ALABAMA
PORT AUTHORITY
PORT OF MOBILE

Second Addendum

Project Name **Main Gate Realignment**

Project # **11447 Task 2** **November 2025**

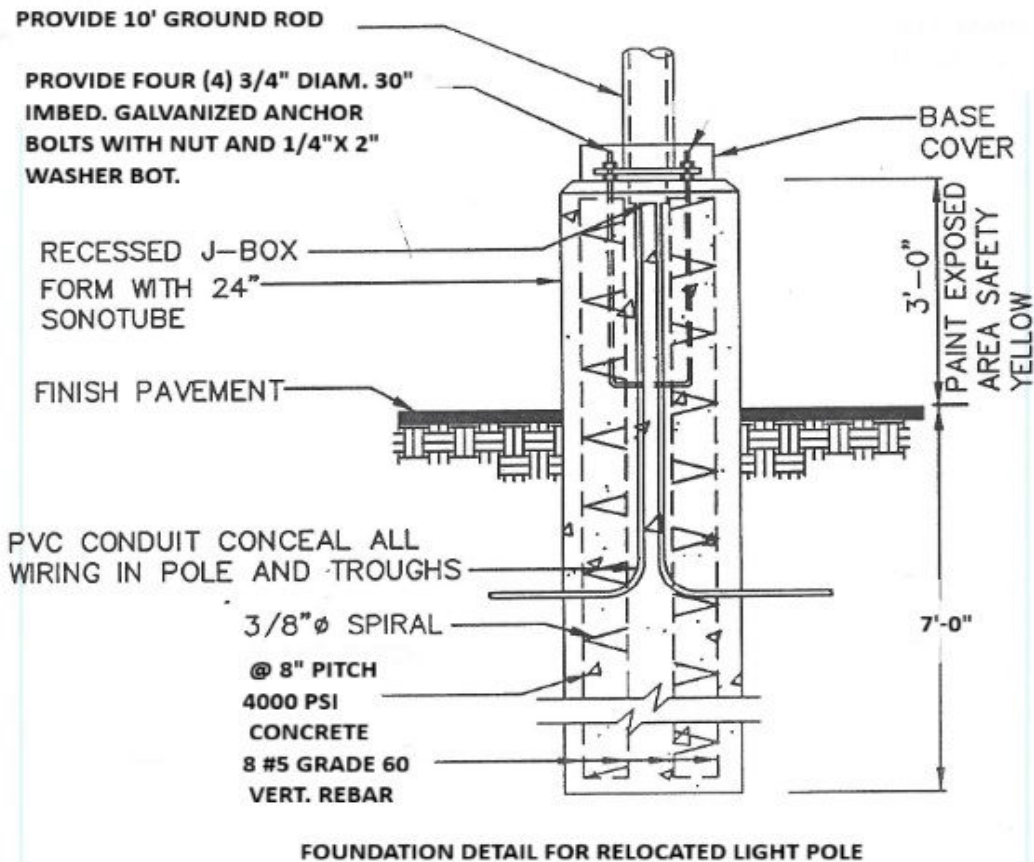
1. Existing Guard Shacks are to be removed by contractor and placed as directed by owner then retained by owner.
2. Existing light pole to be relocated 10' west of its current location as shown on sheet C200. Provide new cast in place concrete foundation:
